# CITY OF LAGUNA HILLS

October 19, 2023

**SUBJECT: SITE DEVELOPMENT PERMIT NO. 0147-2023 (LA PAZ VILLAGE SENIOR LIVING)  
COMPLETENESS REVIEW (SEPTEMBER 22, 2023 RESUBMITTAL)**

4-SIDE ELEVATION

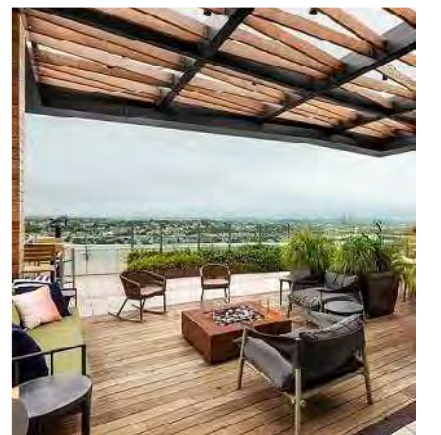
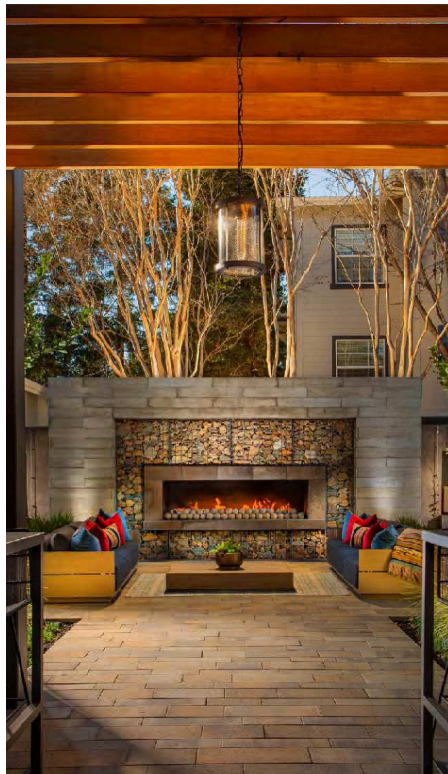
- Sheet 2 of the Building Elevations shows the same elevation for the Rear and Side, please correct or clarify this apparent discrepancy.
  - Plans currently show a parking garage ceiling height as low as 6 feet, which is inadequate. Parking garages, section page, must have an unobstructed headroom clearance of not less than 7' 0" above the finish floor to any ceiling, beam, pipe or similar construction (CA Building Code Section 406.2.2). The clear height of vehicle and pedestrian areas is required to be accessible and shall comply with Chapter 11A or 11B, as applicable.

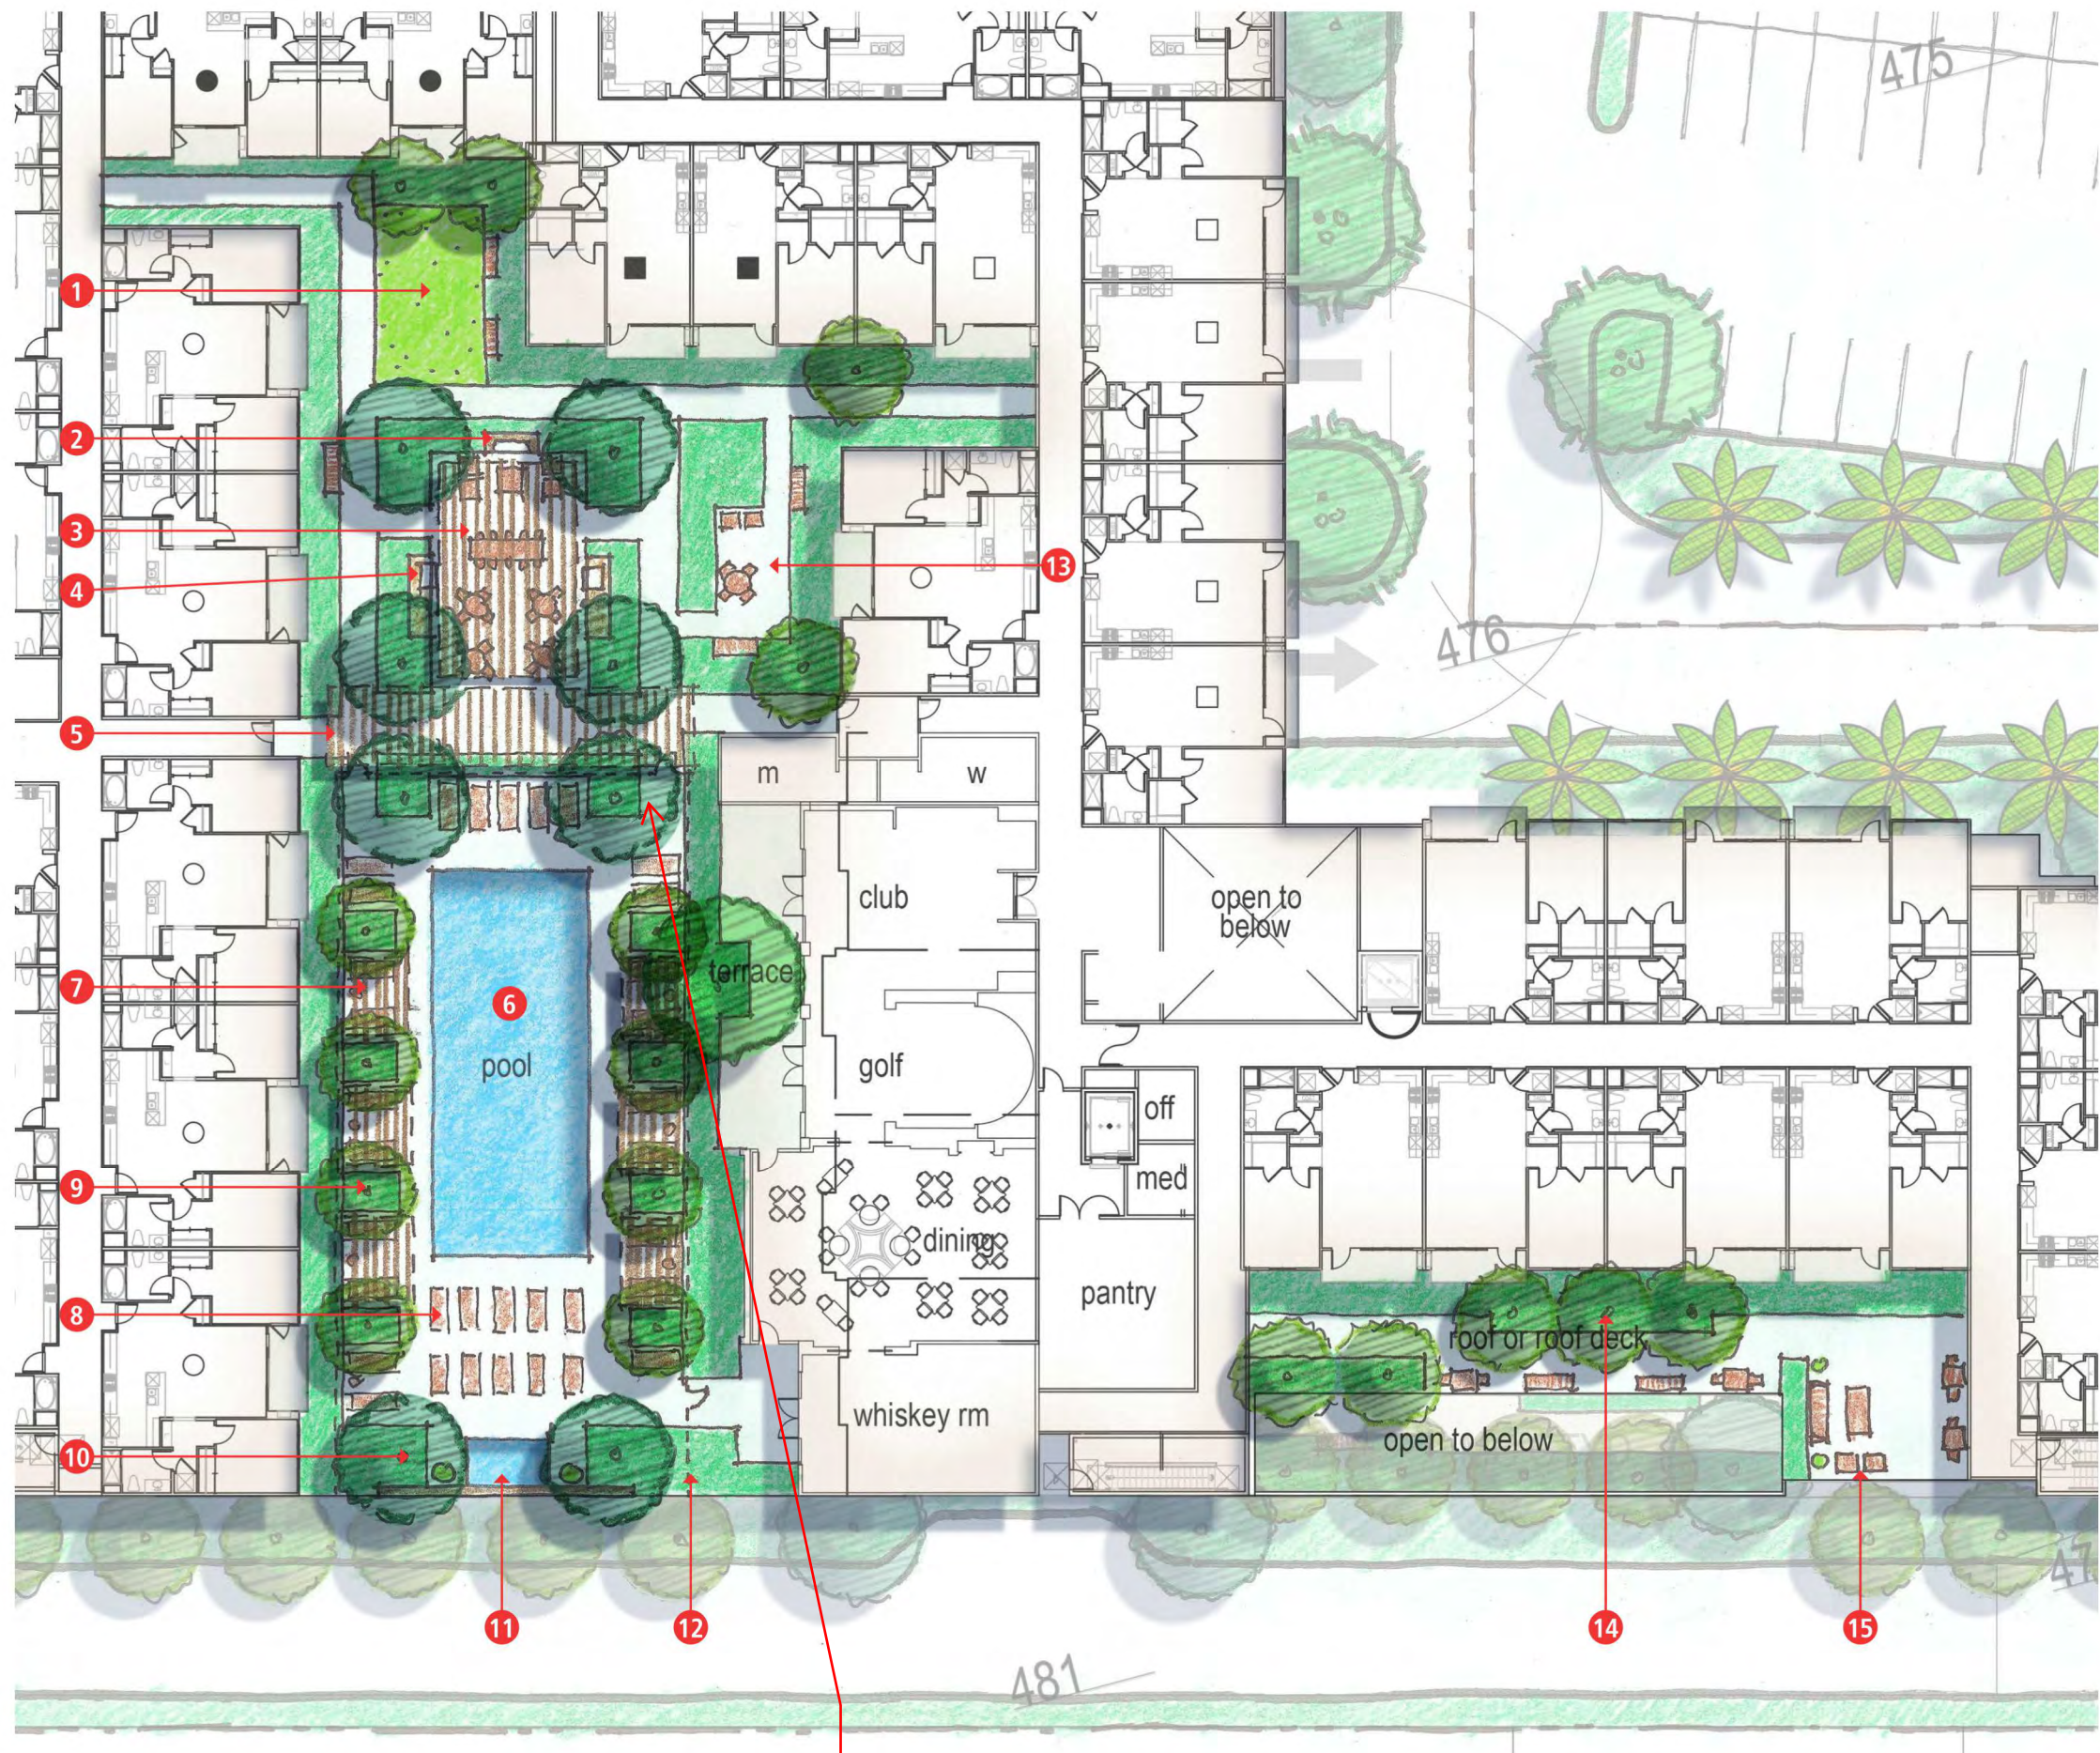
Vegetation & trees obstruct the proposed Fire lane
